GOVERNMENT OF THE DISTRICT OF COLUMBIA
DEPARTMENT OF TRANSPORTATION

MEMORANDUM

SUBJECT: BZA Case No. 18905 – 1216-1226 9th Street NW

Figure 1. Proposed Site Plan (Source: Applicant)

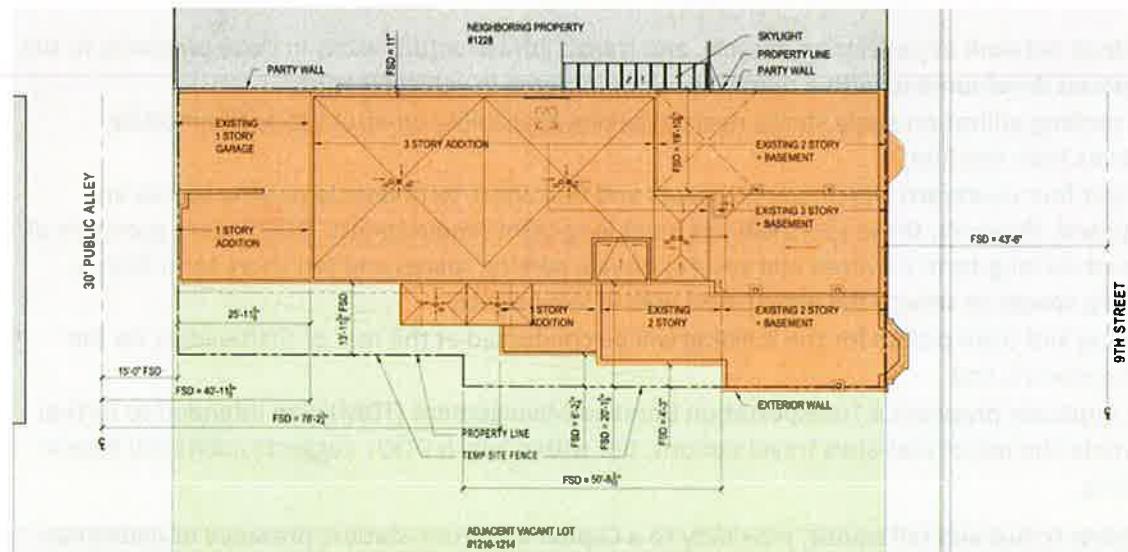
As aforementioned, an adequate pedestrian and bicycle network is available surrounding the Site, and also a Capital Bikeshare station is located near the intersection of M Street and 7th Street. The Applicant is proposing provision of four bicycle parking spaces within the courtyard. However, these spaces should be covered to be considered long-term spaces. The Applicant has also committed to install four short-term bicycle parking spaces in the areas surrounding the building. Full accommodation details (infrastructure provided and its design) for bicycles as well as pedestrians will be coordinated during the public space permitting process.

DDOT suggests provision of at least six long-term (covered and secure) bicycle parking spaces and ten short-term bicycle parking spaces to serve the expected high bicycle usage possible for the planned retail components if they include a gym and restaurant.

Figure 2. Parking Study Area and Parking Restrictions (Source: Applicant)

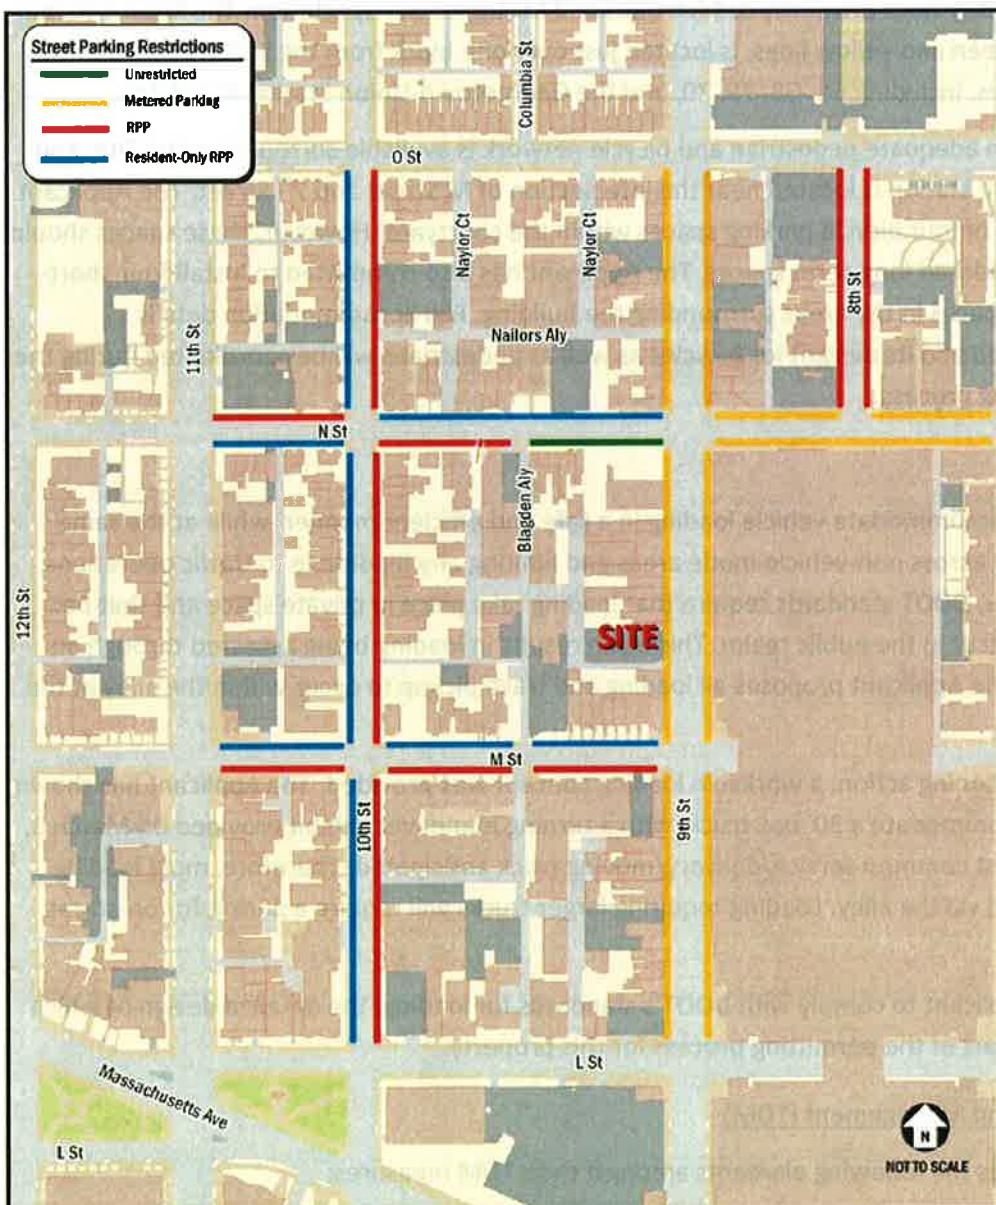
The projected trip generation for the Site expects four auto-based trips originating in the AM and nine in the PM peak hour, illustrating the relatively low amount of parking turnover anticipated on a day-to-day basis. Existing parking utilization information for an appropriate parking study area (shown in *Figure 2*) was provided, and this analysis shows unused nearby street parking at a minimum of 22 spaces.

Generally, DDOT has no objection to reduced parking provision if documentation as to where parking could occur is made and if the overall available transportation network supports an appropriate split between vehicular, transit, pedestrian, and bicycle trips. Thus, DDOT finds appropriate the lack of parking provision in this area due to the close proximity to transit, provided bicycle storage, nearby available parking, and the overall relatively minor increase in vehicular trips.
